TM-2013-01

Technical Memorandum

Subject: Steel reinforcement in 24SF units on installations requiring geogrid

24SF REINFORCED WALL CROSS SECTION

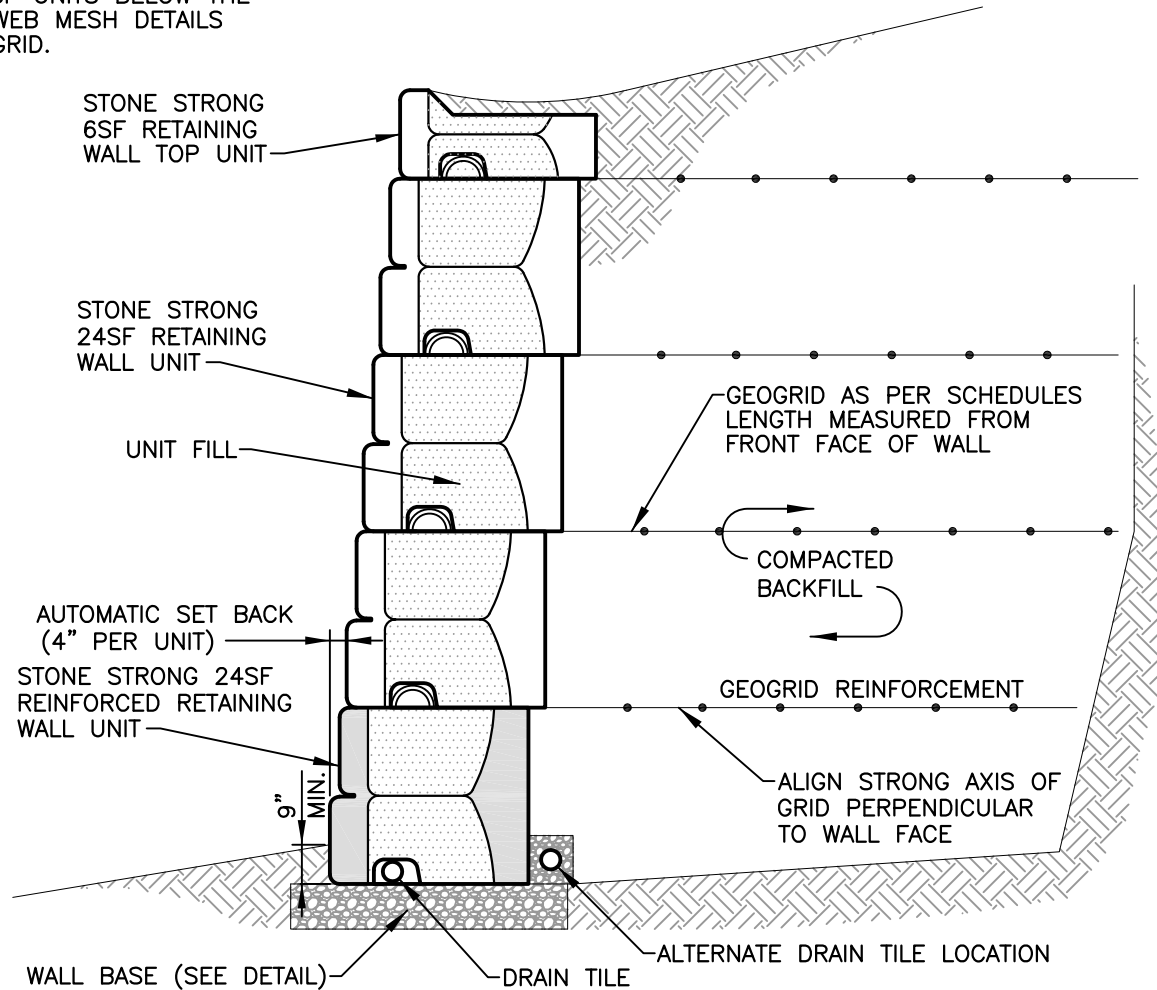
For a geogrid retaining wall over 12 feet in height, internal reinforcement shall be utilized in all 24SF units below the top 12 feet of the wall. To maintain the structural stability of the wall it has been determined that a reinforcement cage should be placed in the 24SF units as part of the production process. Details are attached for a custom mesh cage that may be used in the face and webs for reinforced units. Stock mesh with an equivalent or greater steel area may be used instead, or rebar with an equivalent or greater horizontal steel area may be used.

For a geogrid retaining wall over 33 feet in height, heavy duty internal reinforcement shall be utilized in all 24SF units below the top 33 feet of the wall. As indicated on the details, HD reinforcement may consist of 2 layers of mesh in the face and webs, plus one layer of mesh in the back wall (custom face mesh will require trimming 2 inches from each end for use in rear wall), or equivalent.

24SF UNITS MUST BE REINFORCED BELOW THE TOP 12 FEET IN GEOGRID REINFORCED WALLS. HD REINFORCING REQUIRED FOR 24SF UNITS BELOW THE TOP 33 FEET. SEE FACE AND WEB MESH DETAILS FOR OPTIONAL REINFORCEMENT GRID.
